Public Buildings Enhanced Energy Efficiency Program

Investigation Report for Century College

1/18/2012

S11-8-E (High School Auto Mech)

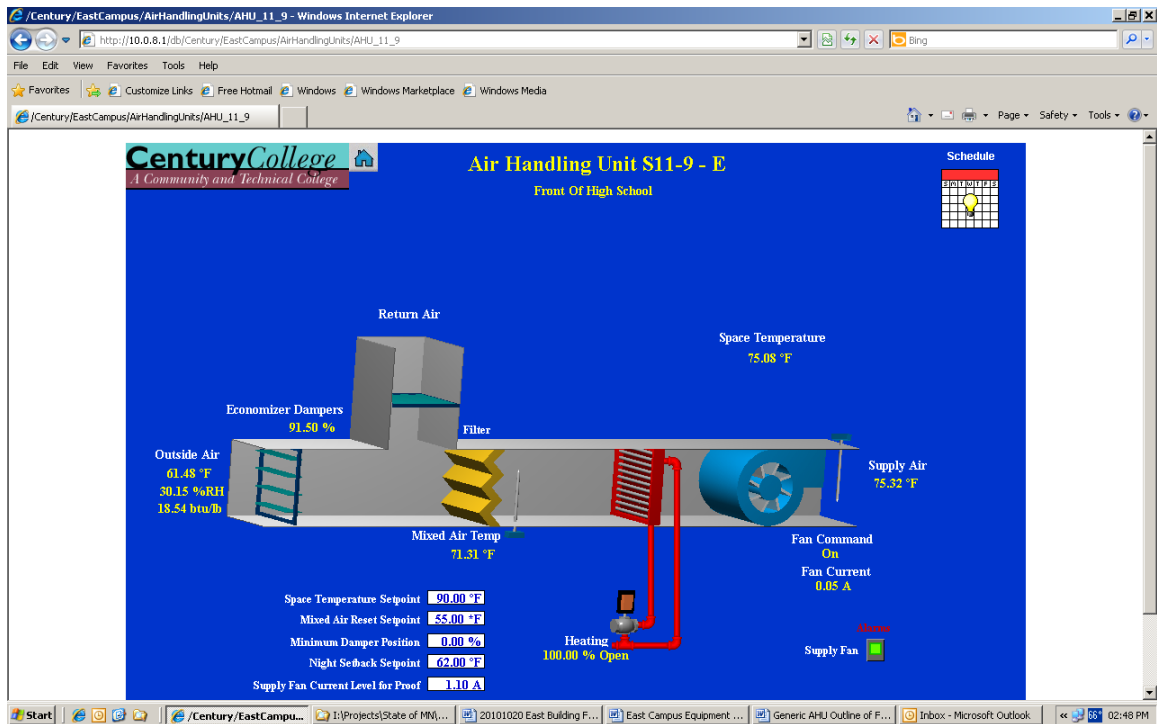
1. Equipment Scheduling and Enabling: Time of Day enabling is excessive.
 - a. The BAS schedule is listed at M-F 6am – 5pm for a total of 55 hours/week. Will need to verify class schedule for actual occupancy of area.

- 6. Economizer Outside Air Loads: Over-Ventilation – Outside air damper failed in an open position. Minimum outside air fraction not set to design specifications or occupancy.

- 11. Control Problems: Other
 - a. The minimum damper position is set to 0% open. Verify the minimum position on the plans; this should be equal to the exhaust fan quantity within that area served by the AHU and associated exhaust fan.

- 40. Retrofit - Energy/Heat Recovery
 - a. Verify the exhaust in this area to evaluate the consideration of adding a heat recovery system.
